From: Martyn White <Martyn.White@arun.gov.uk>
Sent: 29 April 2022 15:05
To: Obafemi Okusipe <Obafemi.Okusipe@arun.gov.uk>
Subject: FW: RE: LU/411/21/PL 90-91 South Terrace, Littlehampton

RE: LU/411/21/PL 90-91 South Terrace, Littlehampton

Photograph showing the adjacent terrace with a render finish to the 1st floor

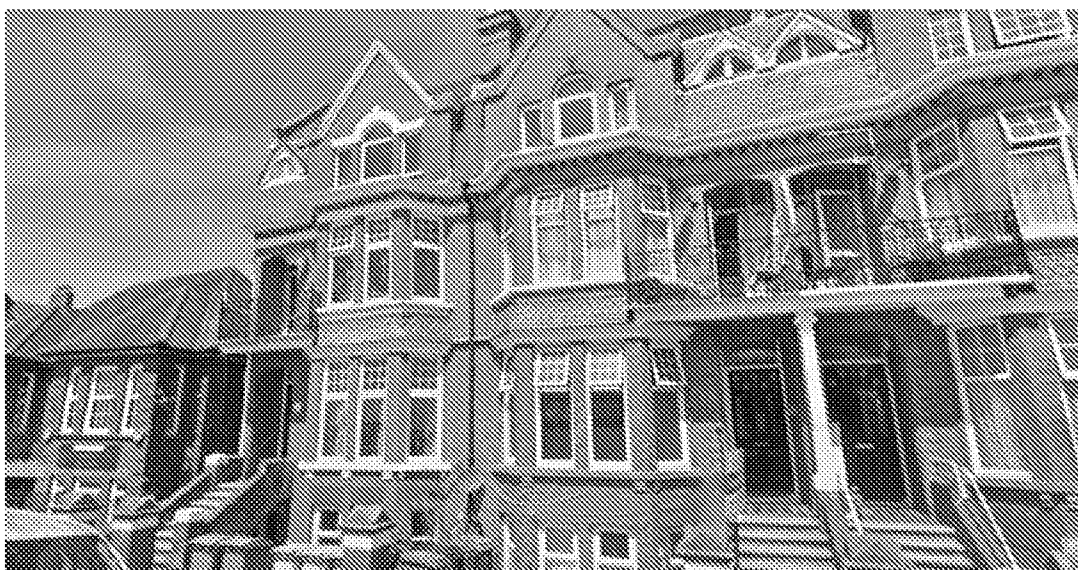
Render to the first floor (to match that of the neighbouring terrace) was chosen as my client, the contractor felt it would difficult to match the new brickwork above the existing given the existing is 100 years old and weathered accordingly. We felt the join between old and new could appear obvious and detract from the finished aesthetic and details such as the creasing tile headers over windows would be difficult to recreate using modern construction techniques. Use of a sand/ rough render finish at this storey height would match with the same storey finish on the terrace to the east of the proposal, so is not out of keeping with the adjacent street scene

Another reason for utilising render on this new additional storey is the construction to the new upper floors is to be lightweight construction to assist in reducing load on the existing structure, a render finish would enable a lightweight supporting structure to reduce weight. The use of a render would acknowledge the fact this is an evolution of the building. The render would only be to the 1st floor so would be at the same storey as the render on the 1st floor of the adjacent terrace (see photo below).

Just to clarify my comments below, I am happy with the revised designs as they now reflect the previously approved scheme and deal with my objections regarding the use of materials. The use of bricks and clay tiles means that the scheme is now acceptable
